CBE190169 - PTPOWER 35

# PTPOWER 35

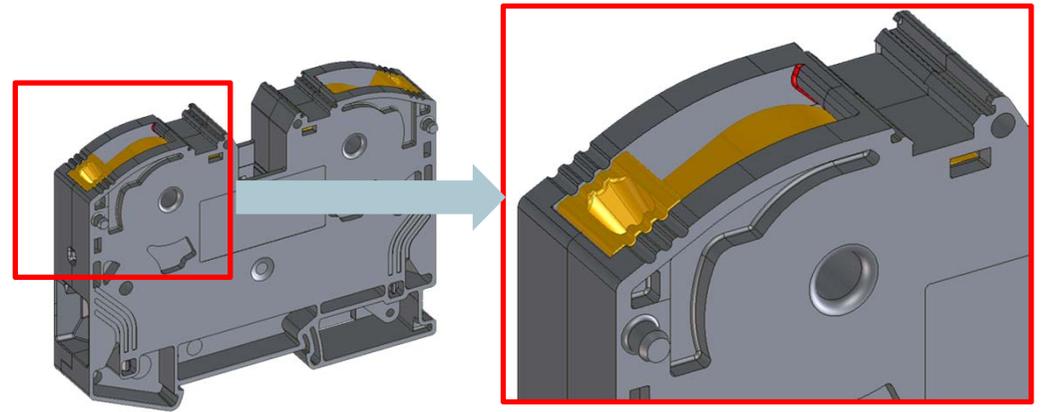
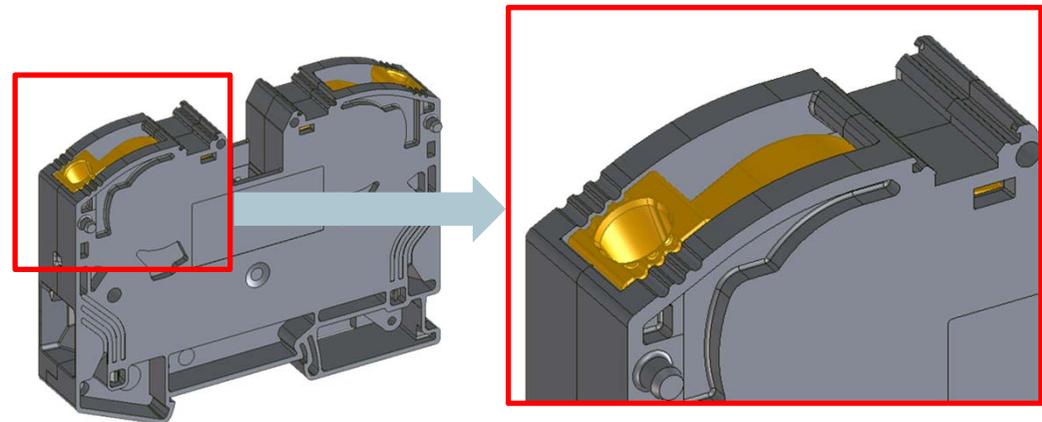
- Old Design of Lever
  - Only the SZF 3 – 1206612 was approved für operation

- New Design of Lever
  - The lever is now approved for the operation of:
    - SZF 3 – 1206612
    - SZS 0,8x4,0 VDE – 1212508
    - SF-SL 0,8x4,0 – 100 S-VDE – 1212588
    - SF-PH 1-80 S-VDE - 1212693

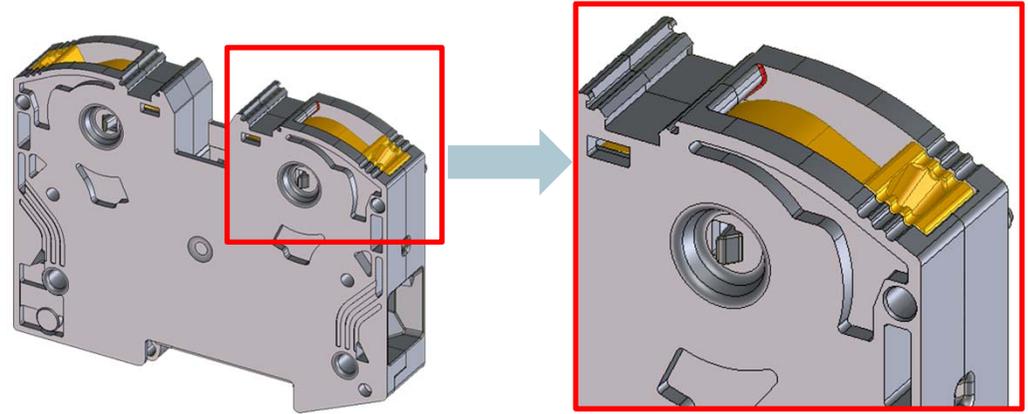
- Old Design of Housing
  - Snap connection of both housings halves

- New Design of Housing
  - The connection is now realized with a screw to create increased stability.
